Responsible: Dieter Rutz  
Date: 07.09.2011

### New Dryer condenser without NTC IWT 1466-OW

1. NTC assembled on the condenser

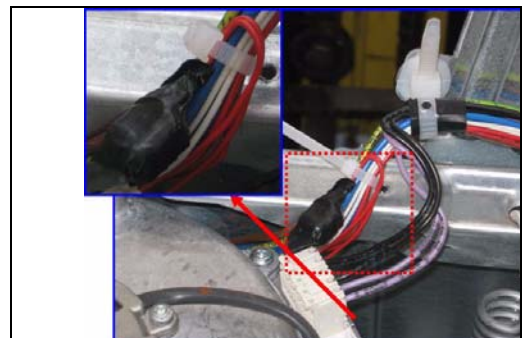
From the upcoming production - run out of the stock - we will introduce the new condenser without the hole for NTC probe, and new wiring without the wire for the NTC. Replacement of an "old" condenser (equipped with a probe) with a "new" condenser (**spare-parts no. 439418**), please follow the attached photo/instruction in order to guarantee the right positioning and insulation of the wiring and the NTC.

**The new condenser can replace the old condenser. Warning: not vice versa!**

2. Completely tape the connector.

3. Anchor the connector to the wiring using a fastener.

4. Change the condenser.
